DRAWN & DRAFTED BY	YE JIN HONG	TOLERANCES	ANGLE:	TITLE:
CHECKED & APPROVED BY	JOHN RONG	$0 < L \leq 4 \pm 0.1$ $4 < L \leq 16 \pm 0.2$ $16 < L \leq 63 \pm 0.3$	$\pm 1^\circ$	T-H BOBBIN BP-E28P
		PIN PITCH ± 0.2	UNIT: MM	BOBBIN MATERIAL: PHENOLIC PM9820
			ORIGIN: DG SZ	PIN MATERIAL: CP WIRE
				UL REC. UL 94V-0
				PIN TENSION LOAD: 2.0KG MIN
				DATE: OCT,17'2007
				DRAWING NO. P-2817
				REV. 4

PIN SHINE INDUSTRIAL CO., LTD.

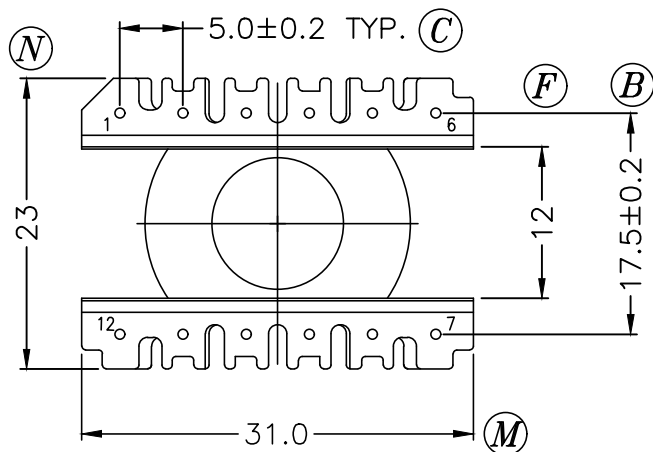
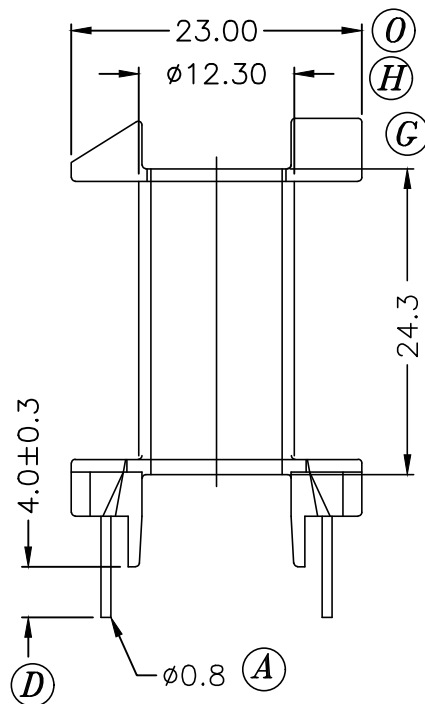
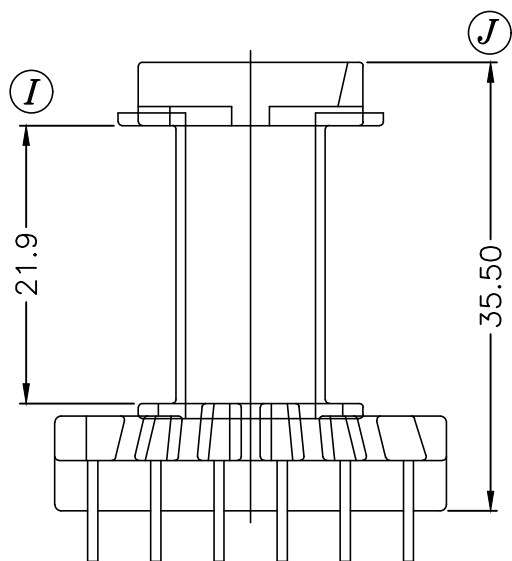
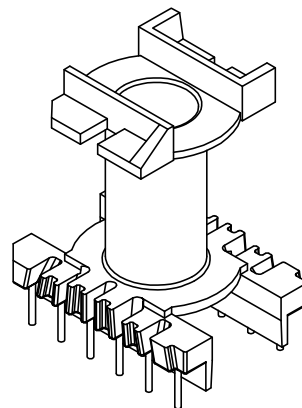
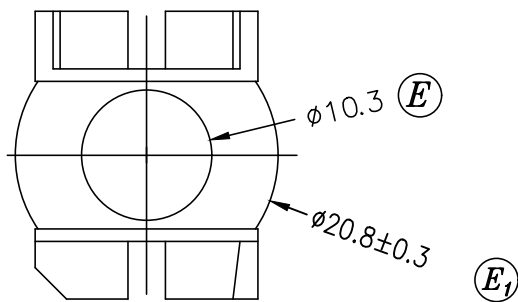
REV.	REVISIONS REC.	DATE	REV.	REVISIONS REC.	DATE.
1	(E): $\phi 10.4 \rightarrow \phi 10.3$ (H): $\phi 12.4 \rightarrow \phi 12.3$ (I): $22.0 \rightarrow 21.9$		3	CANCEL (K),(L),(P); UPDATE DRAWING.	'03.3.20
	(K): $5.0 \rightarrow 5.1$	'98.3.27	4	ADD(F),(E1).	'04.2.03
2	(E): $\phi 10.3 \rightarrow \phi 10.3+0.1/-0$, (B): $17.5 \rightarrow 17.5 \pm 0.2$	'03.2.15
